HAMPSTEAD HEATH PONDS

A CRITICAL REVIEW OF KEY ISSUES BY THE WATER MANAGEMENT STAKEHOLDER GROUP

Revision 01, February 2013

STOCK POND

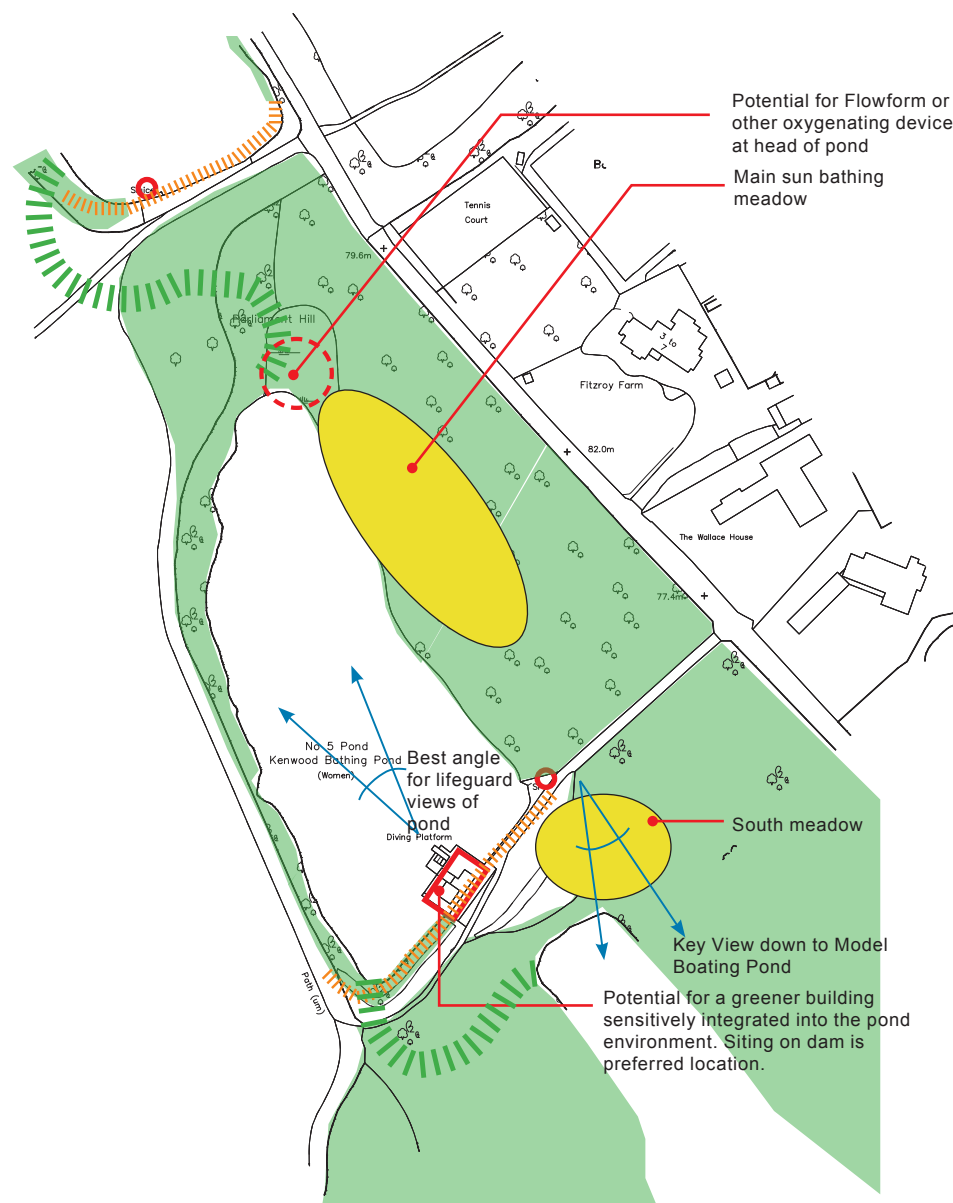
- Loss of vegetation due to changes in water level.
- Loss of intimacy

- Improved discharge capacity
- Minimal visual intrusion
- Preserve natural character
- Improved ecology.
- Sensitive and light clearance of overhanging branches to restore valued 'windows' which are gradually disappearing.
- Water quality improvement
- De-silting
- Leave dam untouched if possible

KENWOOD LADIES BATHING POND

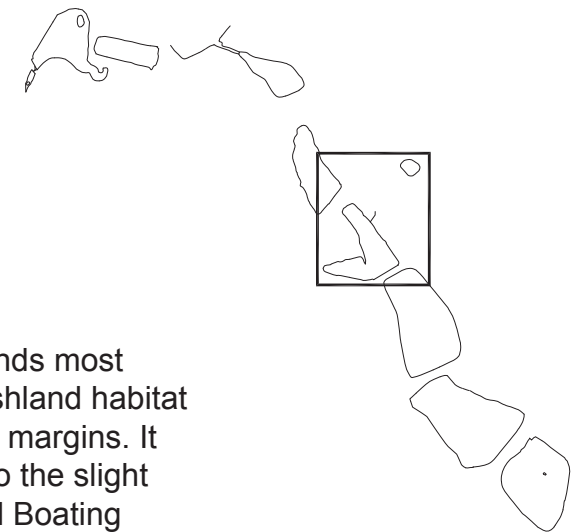
- Change of Ladies Pond dam height impacting on meadow and on existing facilities.
- Loss of intimacy
- Loss of key views from south meadow
- Degradation of water quality through pond works
- Increase in hard standing
- Restriction of access through devices such as turnstiles.
- Impact of works on existing ecology of meadow area.

- Improved soft engineered spillway.
- Maintain spirit of place.
- Improvement of water quality through Flowform Cascade or other aeration device at north end of pond provided that it is unobtrusive.
- Improved ecology.
- If a new facility is required due to changes in the dam configuration then it should be a sustainable low energy building with no increase in footprint.
- Retain historic entrances.
- Leave existing dam in tact if possible.

BIRD SANCTUARY POND

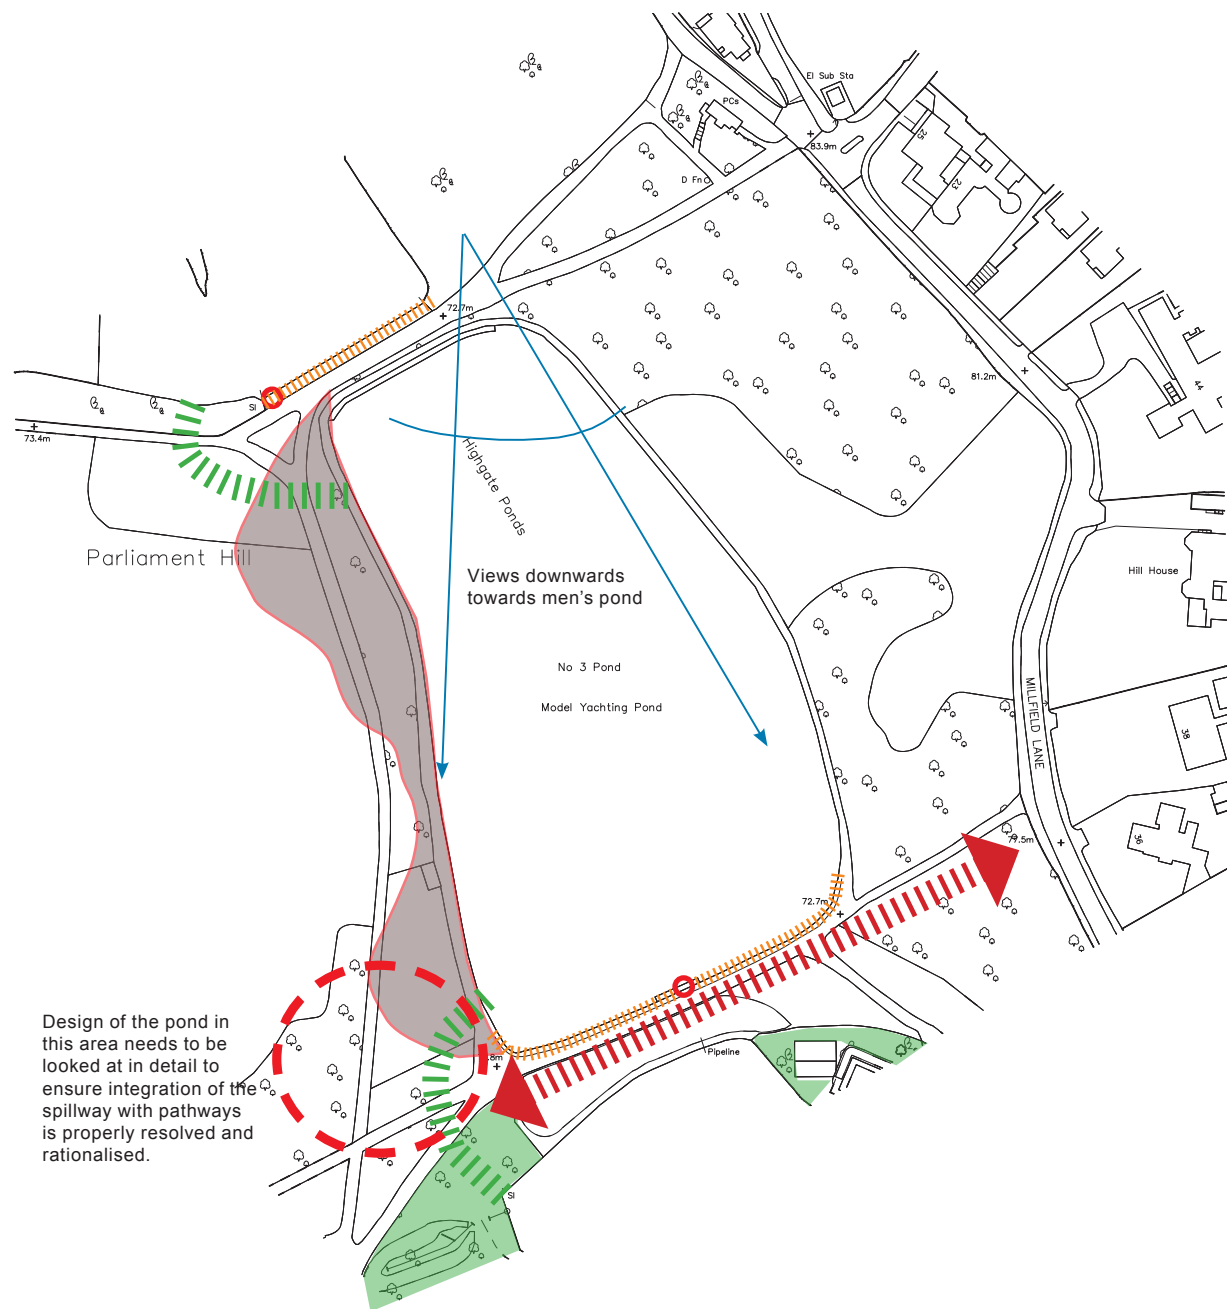
- Loss of Kingfisher nesting if the pond is greatly disturbed. (It has taken over 10 years to encourage Kingfishers to move in to the area)
- Loss of existing vegetation if pond levels are changed.

- Expand area of bird sanctuary.
- Remove invasive species.
- Water quality improvement through aeration and water movement, possibly via Flowform cascade in at northern end of pond.
- No increased storage or attenuation, leave pond alone if possible.
- Consider central dam overflow across existing path instead of constructing a spillway at the south-west corner of pond.

MODEL BOATING POND

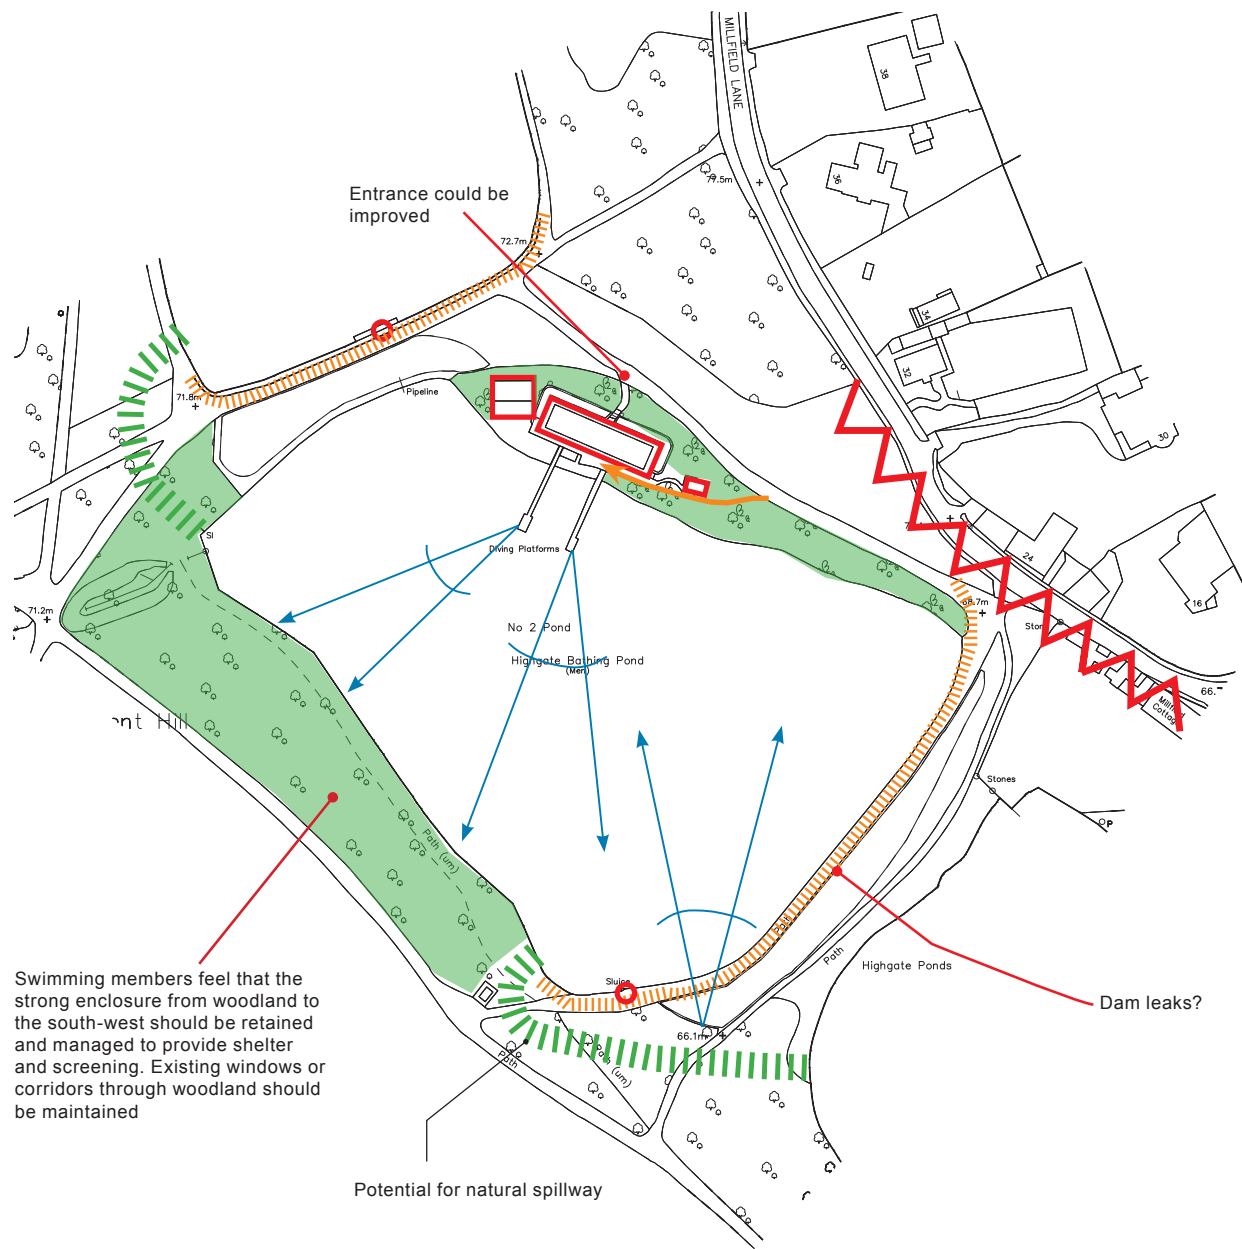
- Loss of openness and views across open water
- Loss of access to waters edge

- Reduce sterility of pond margins
- Improve biodiversity and ecology
- Retain access to waters edge
- Provide a raised dam which provides greater attenuation capacity and with a natural spillway. Permanent water level would remain the same as the current level.
- Retain the ability for the pond to be used for model boating through the use of pontoons or hard edges on the eastern side of the pond.
- Extend the pond through excavation of the western edge to create a shallow and natural edge that acts as an expansion zone during storm events.
- Retain all existing trees
- Naturalise and soften existing dam crest and consider pathway(s) along dam if raised.
- Move fence on south side of dam crest to reduce constrained corridor.

HIGHGATE MEN'S BATHING POND

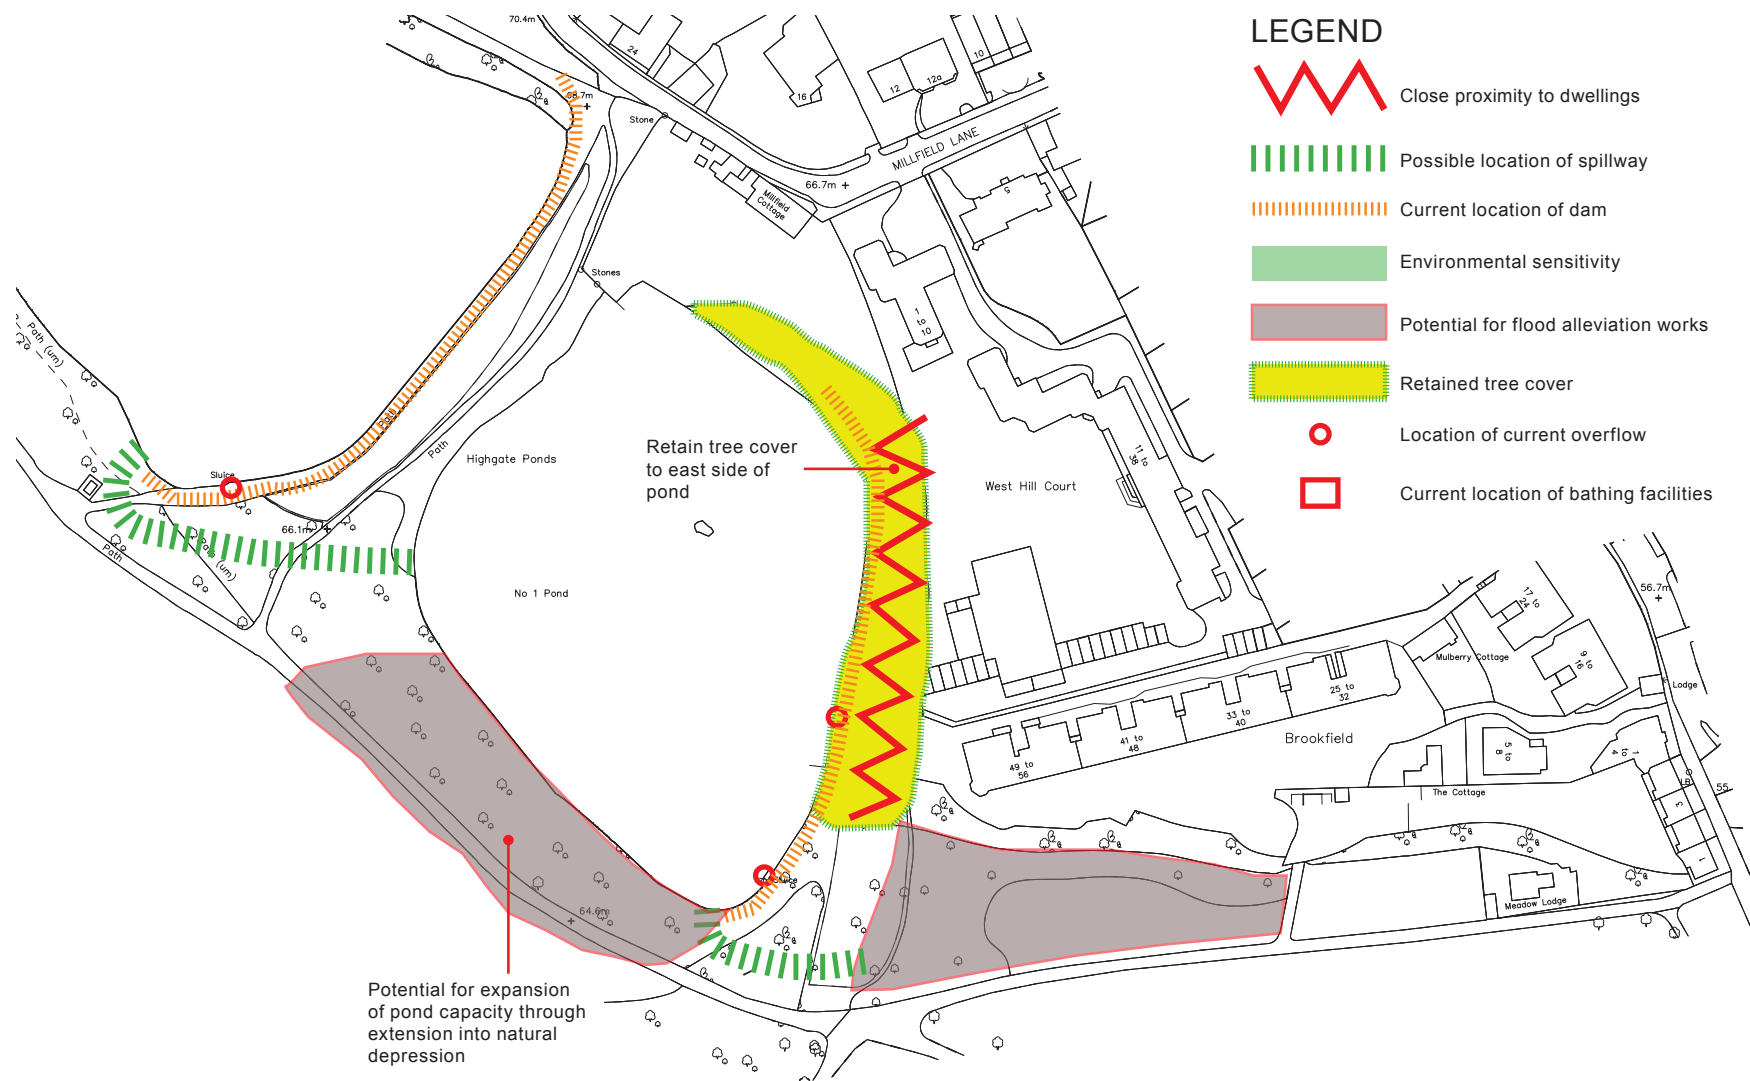
- Impact of major dam works on Boating Pond to north.
- Impact of development on neighbouring properties.
- Imposed swimming charges.
- Loss of enclosure.
- Loss of trees in woodland to the west of the pond.
- Loss of Poplar trees on downstream slope of embankment.

- Improved spillway to the south west corner
- Improved access to facilities for disabled via an additional entrance from the north-east path that would adjoin the current path from the changing area to the toilets.
- Keep the existing Men's Pond entrance open.
- Keep the Men's Pond toilets male only and add disabled facilities.
- Consider a small sunbathing area on the bank alongside the jetty.
- Water quality improvement.
- Existing 'windows' through woodland to the west of the pond maintained or enhanced.
- Naturalise and soften artificial dam crest and possibly move fence down the slope to remove from skyline views.
- Improve attenuation capacity by raising dam.
- Remove intrusive fence on west side of pond.

HIGHGATE No.1

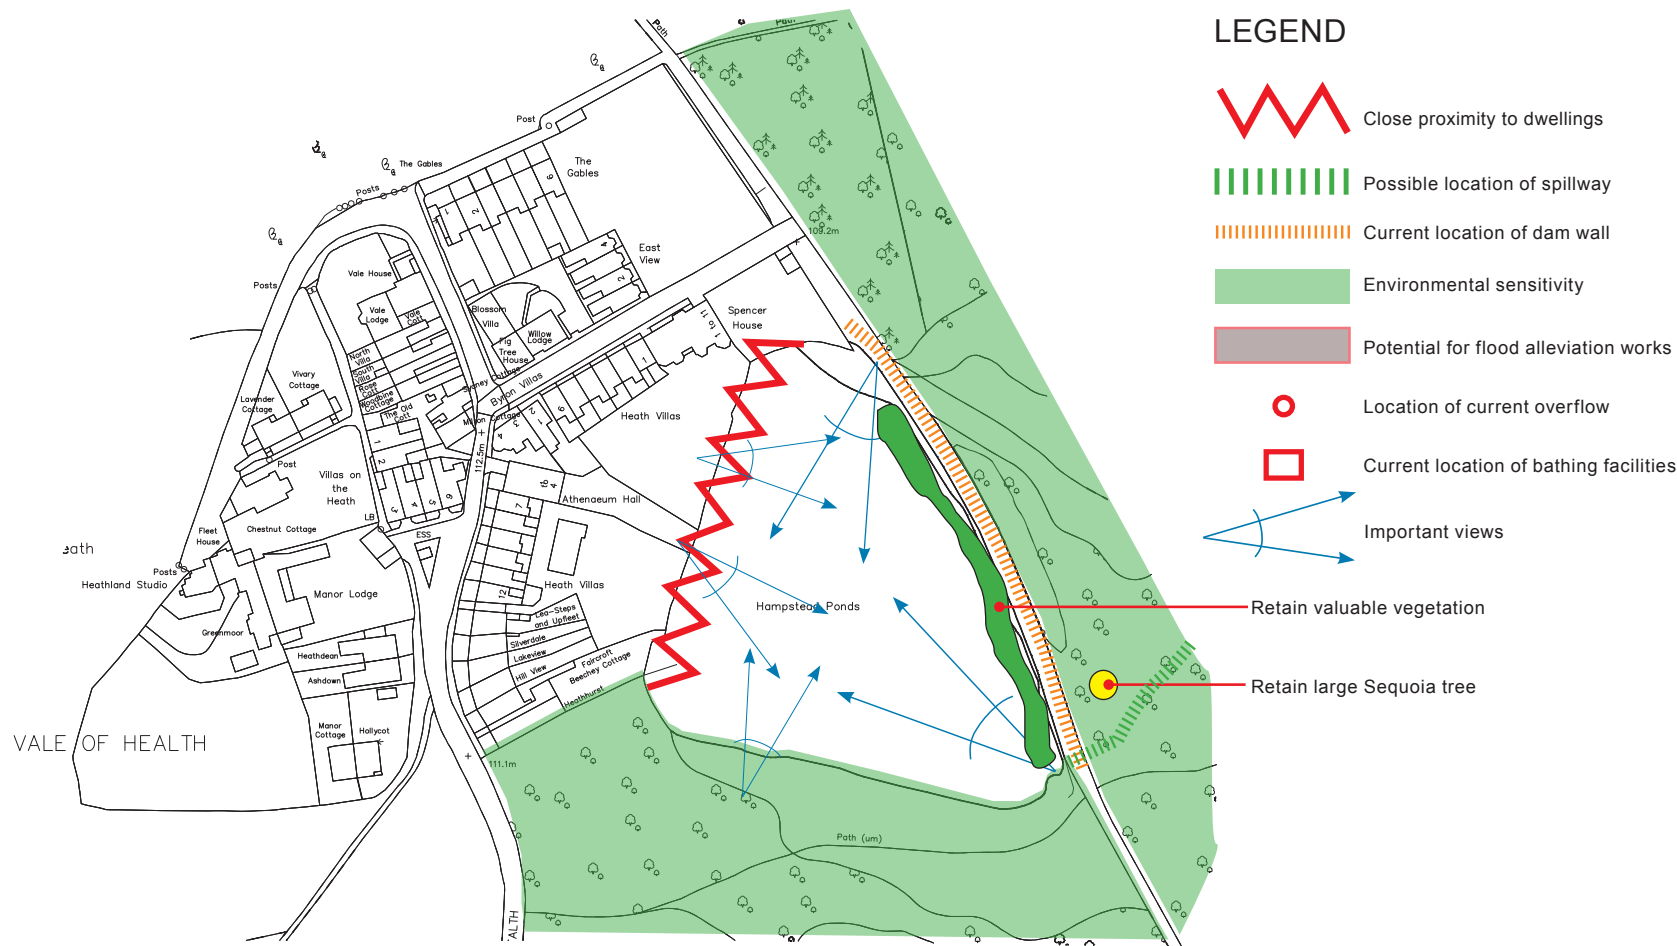
- Loss of Vegetation on eastern edge and on dam if works are required.
- Loss of vegetation to the south of the dam which is particularly rich in biodiversity.
- Loss of enclosure of pond.
- Impact of development on Brookfield Mansions.
- Residents would like pre-development surveys carried out to measure the impact of works on the structure.

- Enhanced protection flood protection for Brookfield Mansions and other residents.
- Raising of the dam should be avoided if possible and additional storage capacity could be created by excavation and lowering of permanent water level.
- Consider expansion of the pond further west up to the existing pathway to create additional storage capacity.
- Improved management of overflow and potential for environmental improvements east of the dam.
- Any alteration below the dam wall should be viewed in relation to the flood protection offered to Brookfield Mansions.
- Water quality improvement.
